ADDENDUM NO. 4

TO: PLANS AND SPECIFICATIONS FOR STATE OF MISSOURI

Renovate Mechanical / Electrical / Life-Safety / State Office Building
Jefferson State Office Building
205 Jefferson Street
Jefferson City, MO 65101
PROJECT NO. O1911-01

SHEET NUMBER:
S1.0

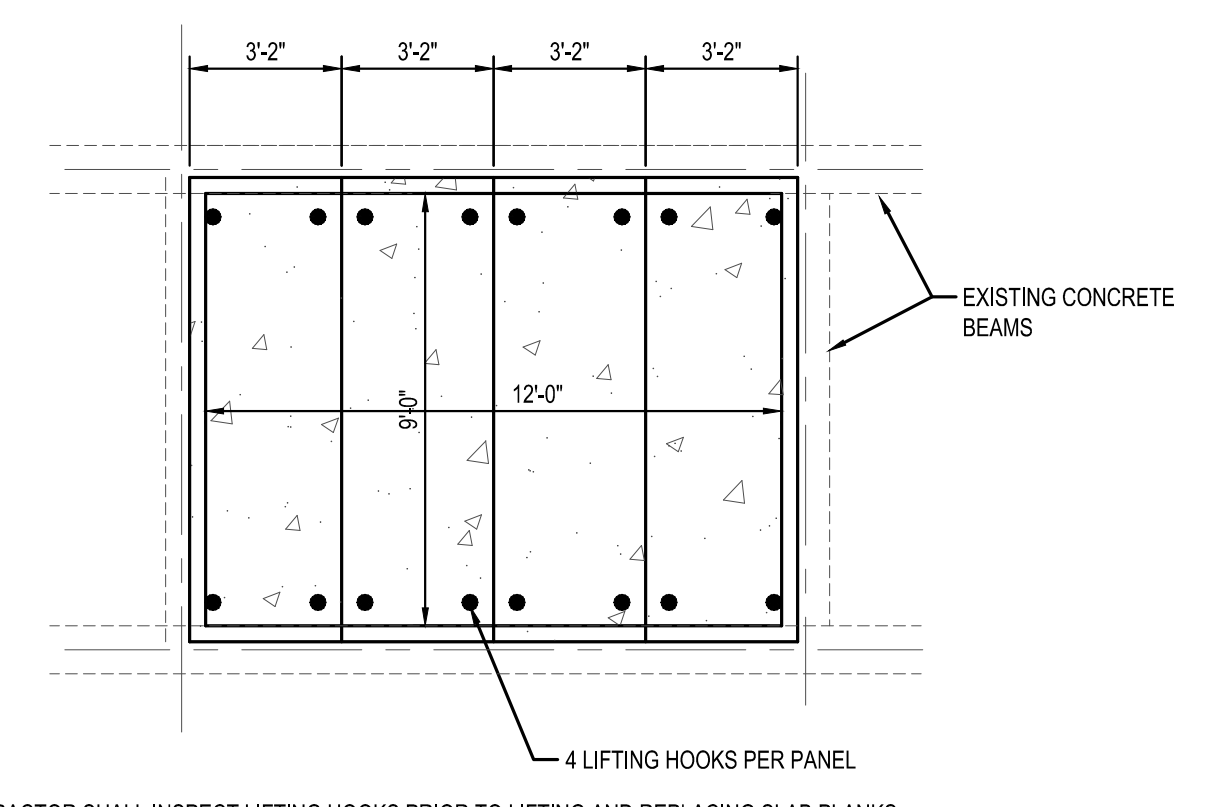
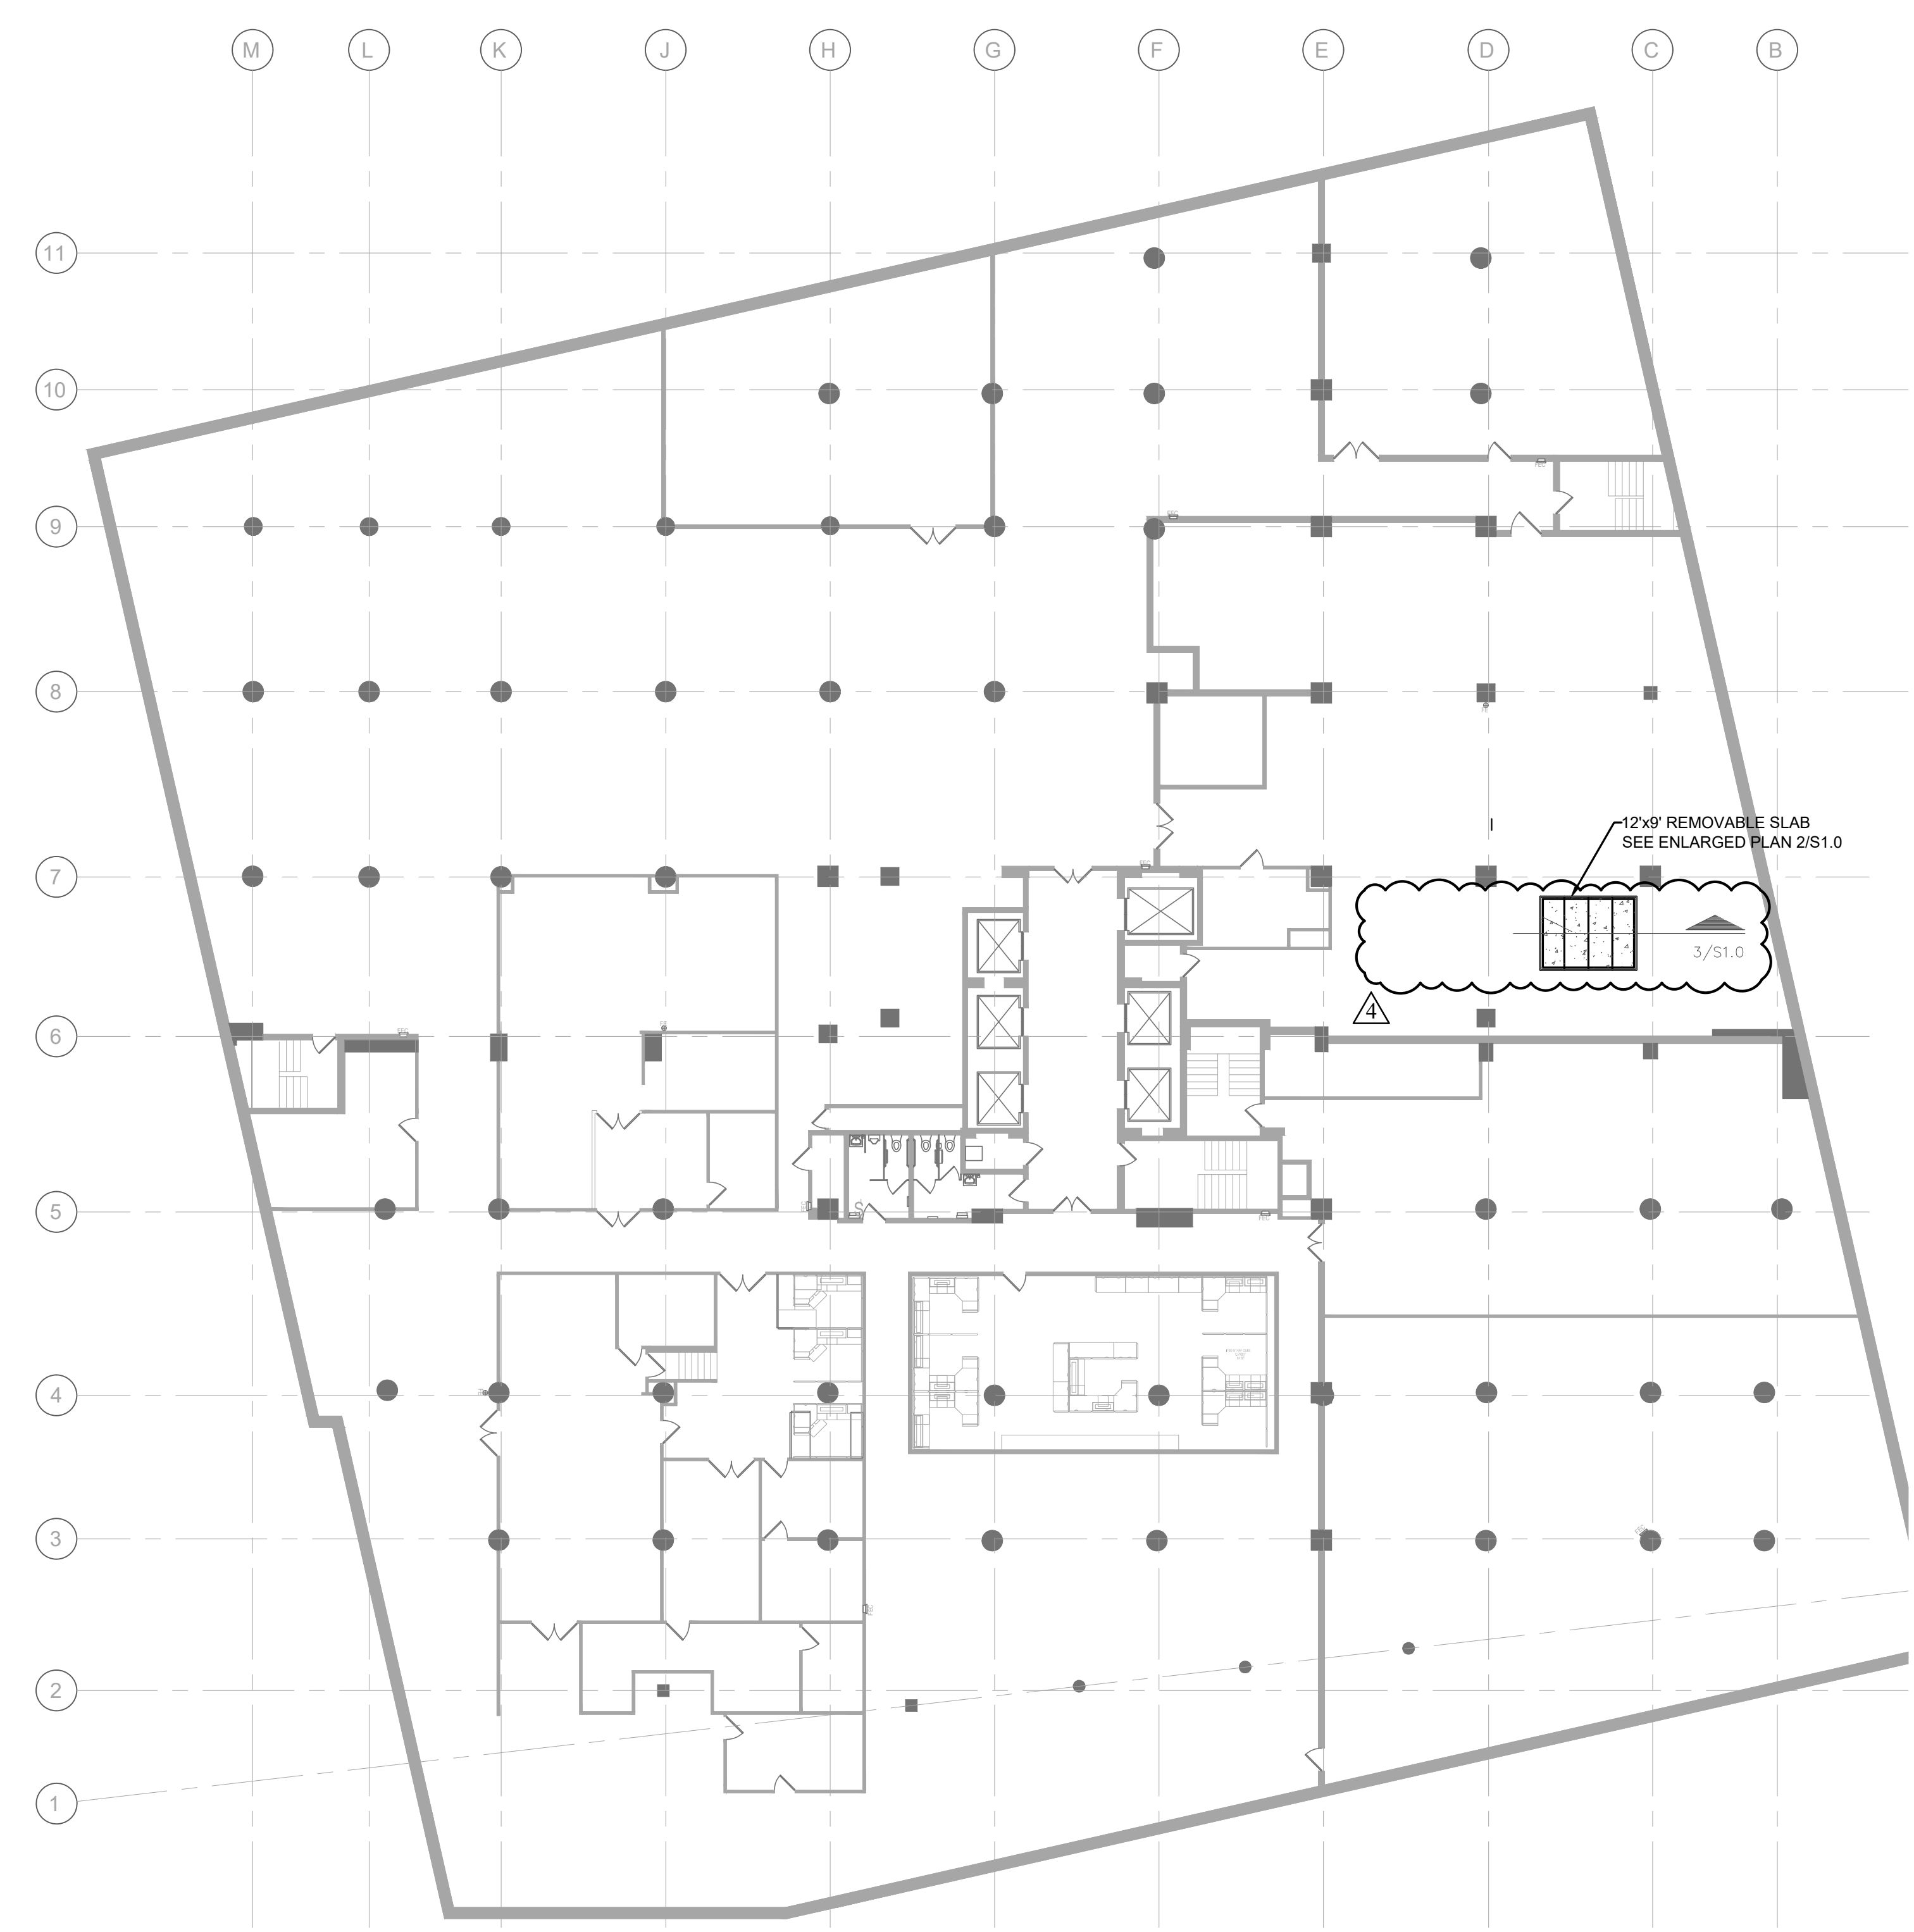
5. Drawing S-1.0:

- a. **UPDATED** – Removable Slab Detail to correct location.

Response: **UPDATED** Sheet S1.0 & S1.1 to show correct location.

S1.1

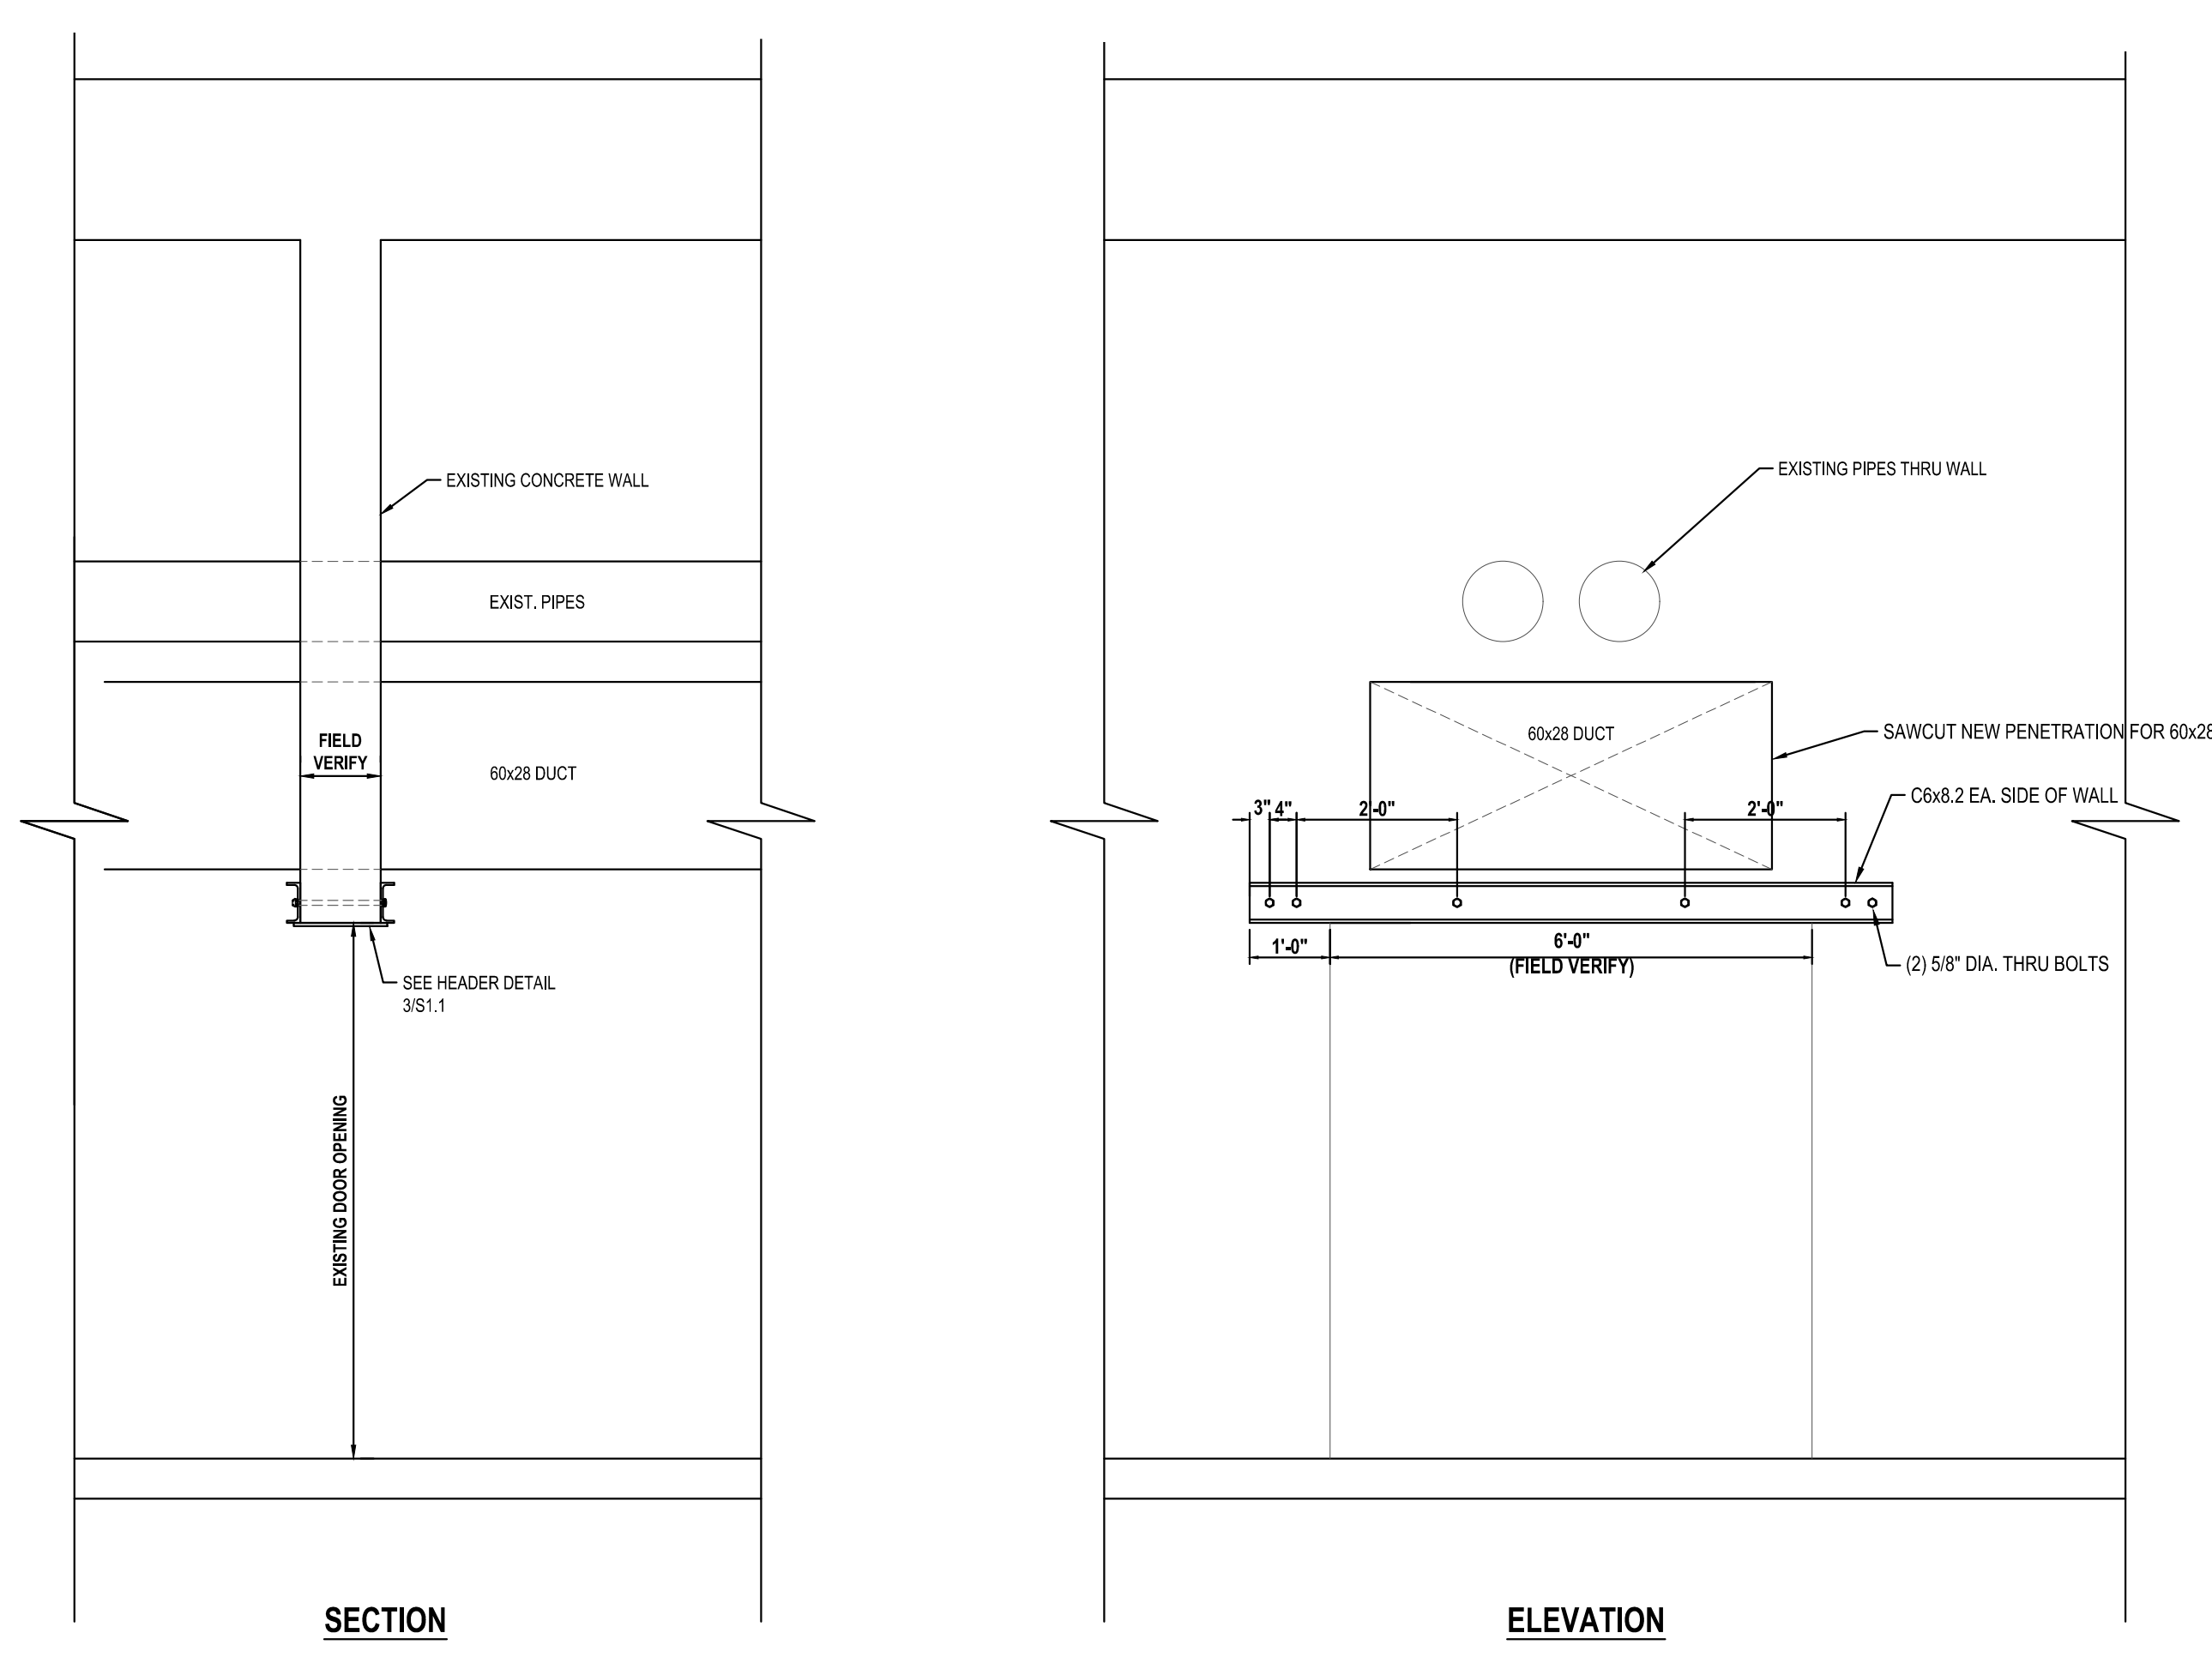
- a. **UPDATED** – Removable Slab Detail to correct location.
7. Drawing S-1.2:
 - a. **CORRECTED** – drawing scales.
 - b. **CORRECTED** – floors associated with plans.
